Western Harbour Tunnel and Warringah Freeway Upgrade

Appendix C –
Sediment and marine water quality
memorandum

Appendix C1 –
Responses to community issues

Appendix C2 –
Responses to Environment
Protection Authority issues

Figure 1 Sediment sampling locations in the Golder-Douglas (2017) investigation and the subsequent RHDHV investigations

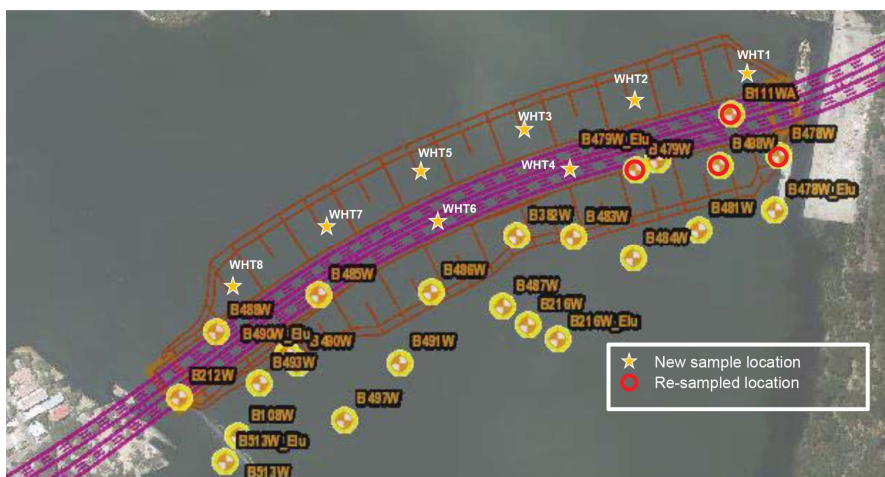
The EPA requested that Transport for NSW provide contaminant levels for any sediment sampling data and pore waters for all the proposed dredging areas. It was noted that the environmental impact statement only provided general information on exceedances of guideline values and that the requested additional data will help inform whether concentrations are at levels that represent a potential risk to receptors.

Existing data reviewed by RHDHV included the results of the investigation by Golder-Douglas (2017). A plan showing sample locations from this investigation and a table comparing contaminant levels to Interim Sediment Quality Guidelines (ISQG) ISQG-High and ISQG-Low values are included in **Attachment A**.

RHDHV sampling was undertaken at eight new locations along the tunnel alignment, denoted WHT1 to WHT8, as shown in **Figure 1**. In addition, re-sampling was undertaken at four previous sampling locations from the Golder-Douglas investigation ('B' series in **Figure 1**)¹.

Figure 3 Schematic of horizontal closing mechanism of environmental clamshell (source: Boskalis)

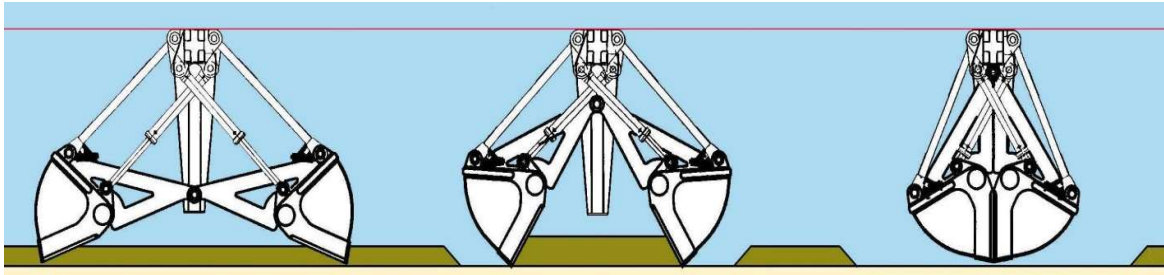
In their submission the EPA has raised the matter of mitigation measures that may be required during dredging, particularly in relation to sediments containing elevated levels of contaminants. The EPA includes as mitigation examples:

- options to minimise the resuspension levels generated by any specific dredge methods such as slowing the dredge head descent just before impact with the sediment bed;
- reduced dredging rate or intensity in known contaminant hotspots or near sensitive areas;
- any needed restrictions of access to certain areas;
- warning signs for certain areas and times; or
- any additional key monitoring locations.

As described in the environmental impact statement and noted earlier, dredging of the sediments with elevated contaminants proposed for land disposal would be undertaken by a backhoe dredger (BHD) using a closed bucket (environmental clamshell) (refer Chapter 6 of the environmental impact statement). These buckets have been specifically designed for dredging contaminated sediments and provide three significant advantages compared to conventional open buckets:

Accurate dredging is achieved by real time monitoring and control systems and the fact that the environmental clamshell closes horizontally to provide a level cut as opposed to a conventional semi-circular or arched cut. In this way, relatively thin layers of contaminated material can be removed in a controlled manner.

A schematic showing the horizontal closing mechanism of the environmental clamshell is provided in **Figure 3**. An example environmental clamshell (16m³ capacity) is shown on a wharf in **Figure 4** and in operation removing petroleum contaminated sediments in **Figure 5**.
